APPLICATION NO.	FILING DATE	FIRST NAMED INVENTOR	ATTORNEY DOCKET NO.	CONFIRMATION NO.
10/660,915	09/12/2003	Kevin Damewood	SMCY-P01-103	7338
28120	7590	12/11/2006	EXAMINER	
FISH & NEAVE IP GROUP ROPES & GRAY LLP ONE INTERNATIONAL PLACE BOSTON, MA 02110-2624			SINGH, SUNIL	
			ART UNIT	PAPER NUMBER
			3673

Office Action Summary

DETAILED ACTION

2,649,595

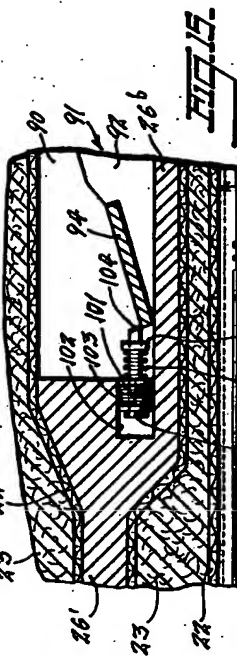
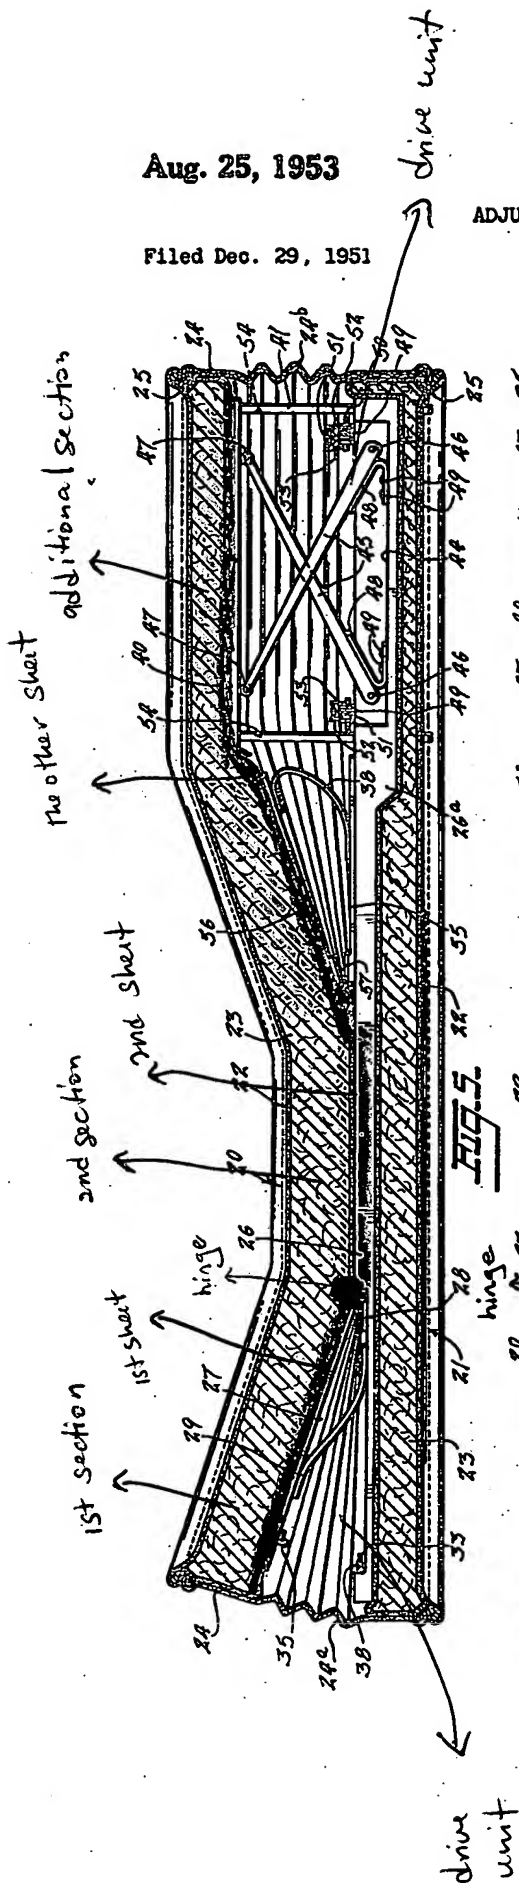
Lewin discloses an adjustable mattress (see Figs. 4-7 and 13-14) comprising a first section and a second section (see attached marked up drawings) overlying a rigid platform (26,26'), the first section and the second section moveable relative to each other (see Figs. 4,5) and together forming at least a portion of a sleeping surface of the adjustable mattress; a first mechanical drive unit (see Figs.5 and 13) within the adjustable mattress, the first mechanical drive unit connected to at least one of the first section and the second section and providing a mechanical force to move the first section relative to the second section; and a flexible sheet (this is considered as the bottom of member (20)) disposed between the first mechanical drive unit and bottom surfaces of the first and second sections, said flexible sheet being continuous in a longitudinal direction of the mattress at least across one of the first and second

sections. The first sheet section (see attached marked up drawings) a second sheet section (see attached marked up drawings) and hinged section (see attached marked up section). One or more additional sections (see attached marked up drawings). Second mechanical unit (see Figs. 5 and 6). Mattress cover (22,24). Padding (23). Foundation (this is considered as the box spring, see col. 4 line 55). Spring core (see col. 3 line 5+). Controller (75). Arms (45). Base element (21) and platform (27,40). Frame (see col. 4 line 55+). The other sheet (see attached marked up drawings).

12. Applicant's arguments filed 9/29/06 have been fully considered but they are not persuasive. Applicant argues that Lewin fails to disclose a first sheet and second sheet connected to by a hinge. The examiner disagrees. As indicated in the marked up drawings, the first sheet is attached to the second sheet by a hinge (see how the mattress moves from Figure 4 to Figure 5 shows there is a hinge connecting a first and second sheet). Applicant argues that member (56) of Lewin is not flexible. The examiner never considered member (56) as the flexible member but instead the bottom of member (20) which is flexible.
